H11747

DESCRIPTIVE REPORT

Registry No. H11747

Locality SAN PABLO POINT TO 1.5 MILES
WEST OF PINOLE POINT

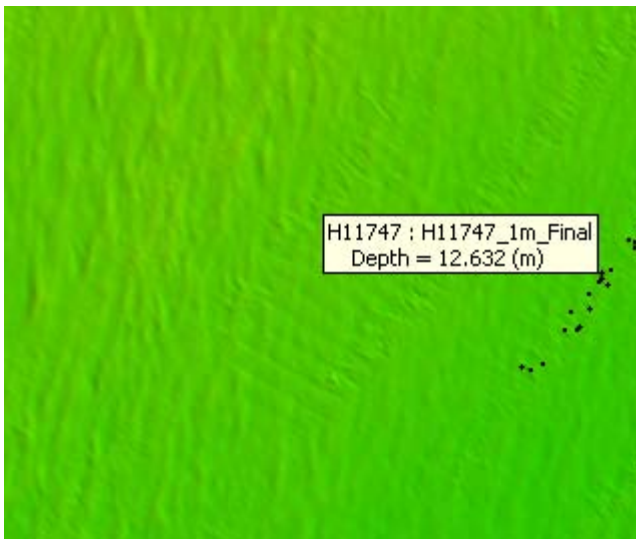
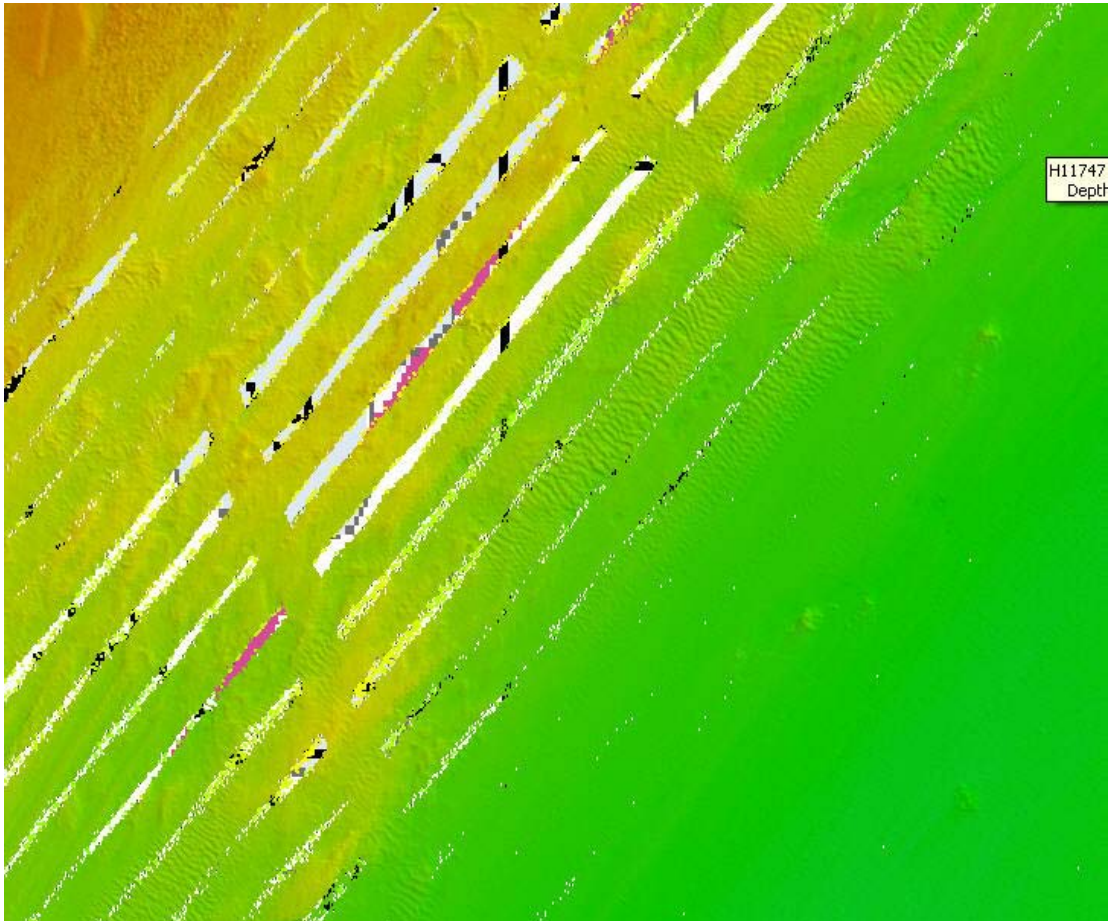
The majority of side scan sonar contacts and their subsequent multibeam developments reveal debris mounds that we believe to be dredge spoils. This is based on their physical characteristics and proximity to the charted “Disposal Area” on the northwest edge of the channel. New depths are charted as appropriate. *Concur with clarification. Some of these dredge spoils deemed significant and are being recommended for charting as obstructions. See Appendix II of this report for charting recommendations.*

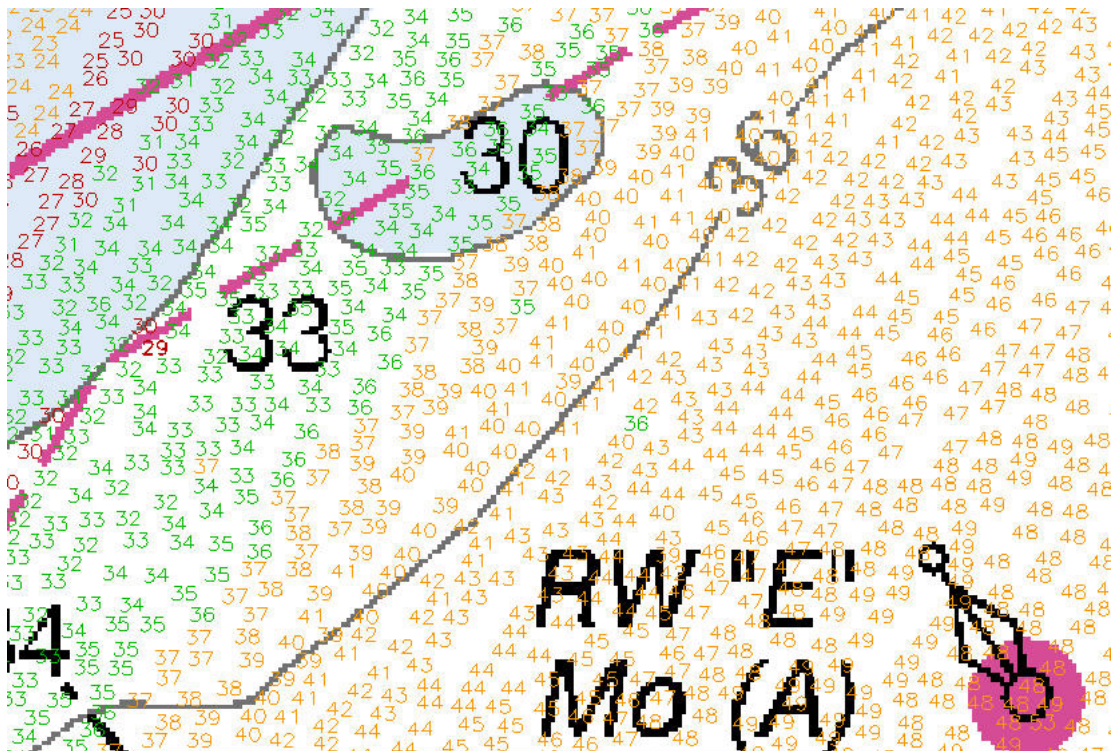
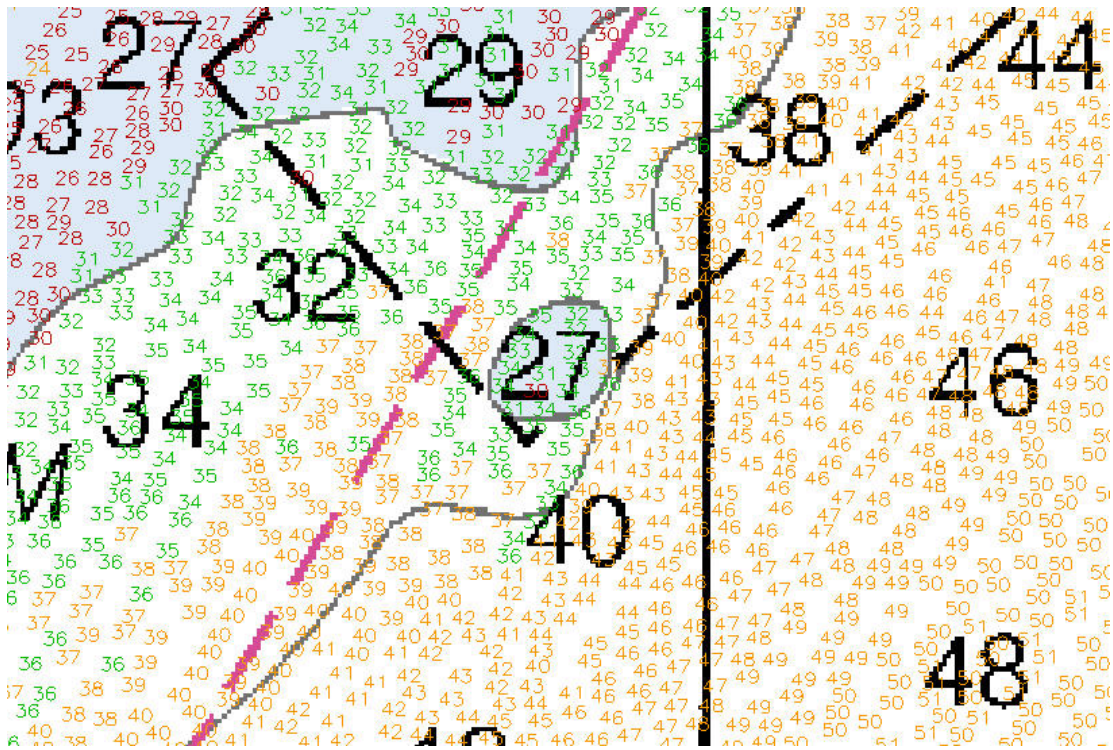
Significant shoaling as a general trend is most visible from the southeastern portion of the survey area where sediment is drifting and migrating northwestward towards the channel. The hydrographer recommends repositioning contour lines to reflect new survey data. See image below. *Concur.*

The acquired survey data also disproves two charted shoal contours that are no longer present. See images below. *Concur.*

1.1) 24 Obstn (Subm pile) - 14685/15

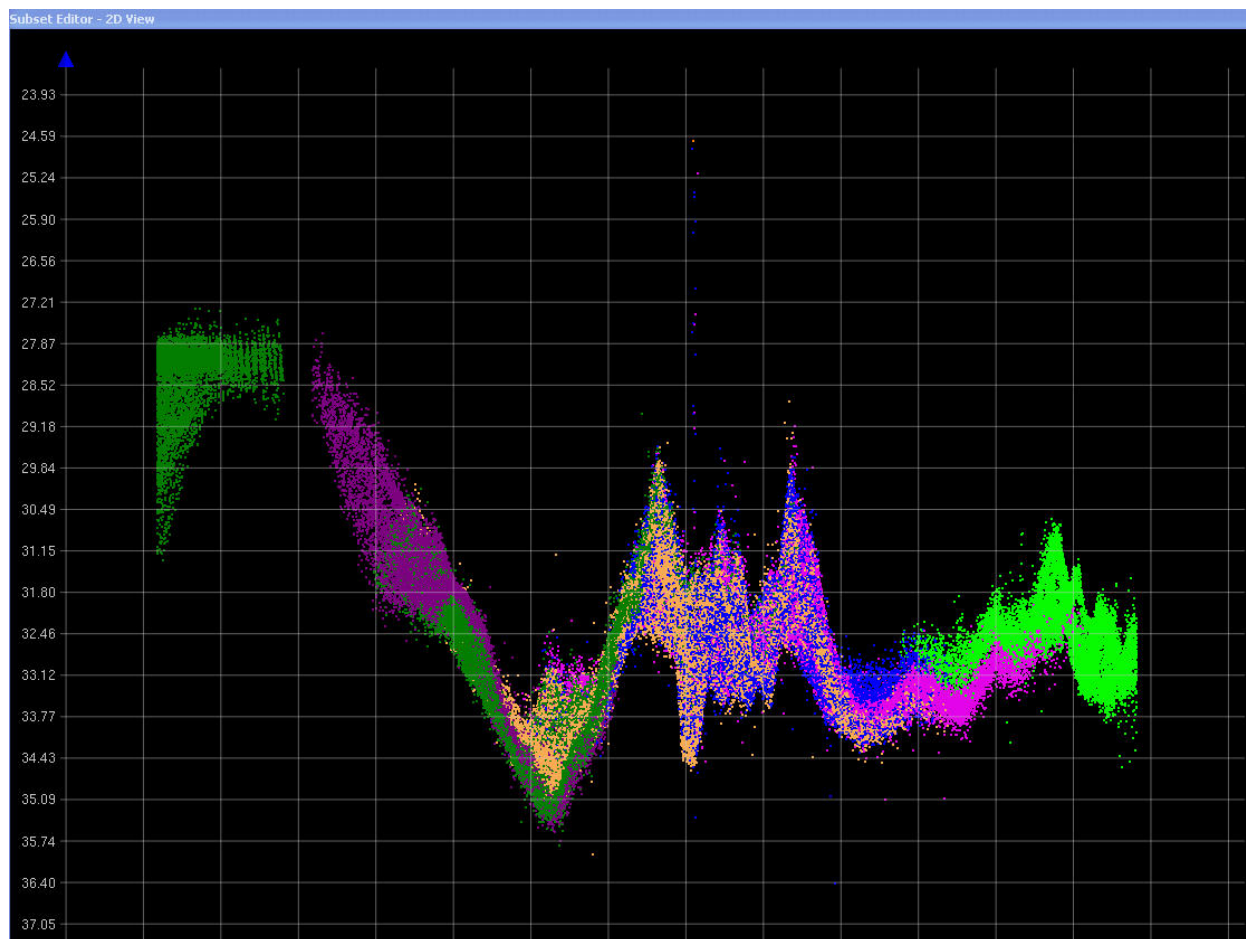
submerged pile. old day mark.

Hydrographer recommends charting with a submerged pile symbol.

Concur_ Add 24 Obstn (Subm pile) in present survey location.

1.2) 37 Obstn - 111/20**Survey Summary**

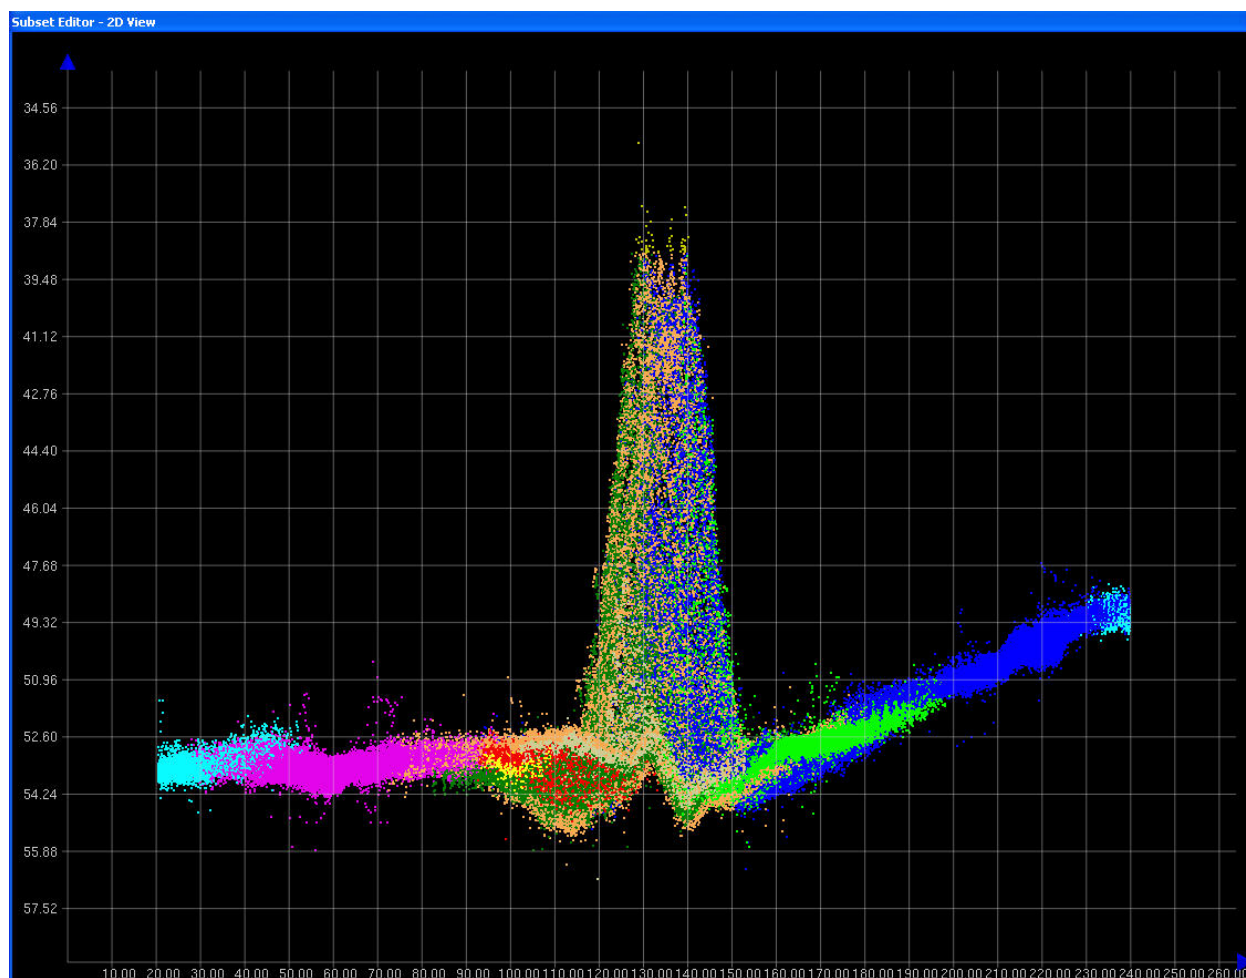
Large debris mound. Update chart.

Hydrographer recommends charting feature with an obstruction circle and updating the charted sounding to 37ft.

Concur - Add 37 Obstn in present survey location.
